**BEFORE THE HEARINGS PANEL  
FOR THE QUEENSTOWN LAKES PROPOSED DISTRICT PLAN**

**IN THE MATTER** of a private plan change to the  
Queenstown Lakes Proposed  
District Plan: Proposed Private Plan  
Change 1 The Hills Resort Zone

**STATEMENT OF EVIDENCE OF BRIDGET MARY GILBERT  
ON BEHALF OF QUEENSTOWN LAKES DISTRICT COUNCIL**

**LANDSCAPE EFFECTS**

**Figure 1:** Recommended changes to the extent of HS 15

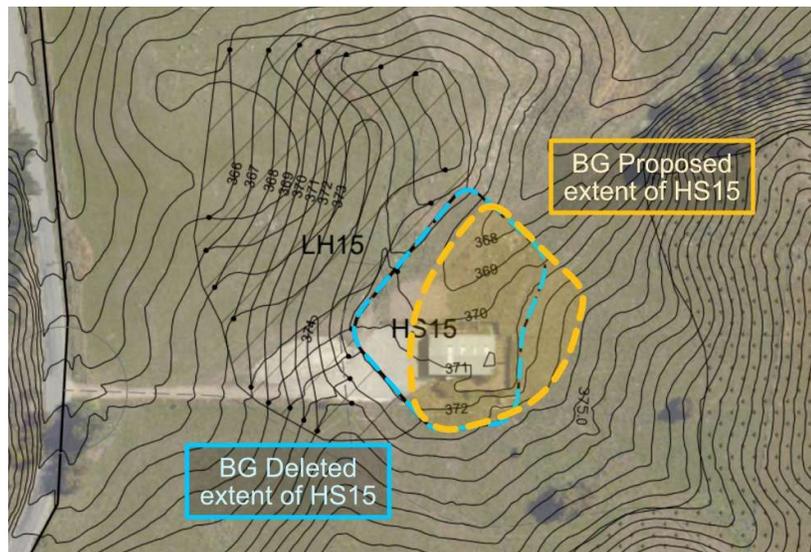
- i. the LAMA mounding height is increased from RL 405m to RL 408m; or
  - ii. The HS ground level RL and building height is reduced by 3m.
- (d) **HS 15:** Despite the notified HS being over 75m from Hogans Gully Road, the roll of the land, combined with the anticipated roof height (RL 377.5m) and road alignment, means that it will read as dominant and

incongruous from Hogans Gully Road, within a setting in which dwellings are typically well integrated by landform and/or vegetation. It is recommended that:

- i. HS 15 is moved further back from the road as indicated in **Figure 1** below; and
- (e) the LAMA mounding height is increased from RL 375m to RL 376m to manage visual effects in views from Hogans Gully Road, or: the HS ground level RL and building height is reduced by 1m which, in my view, will achieve a similar outcome in terms of managing landscape-related effects.
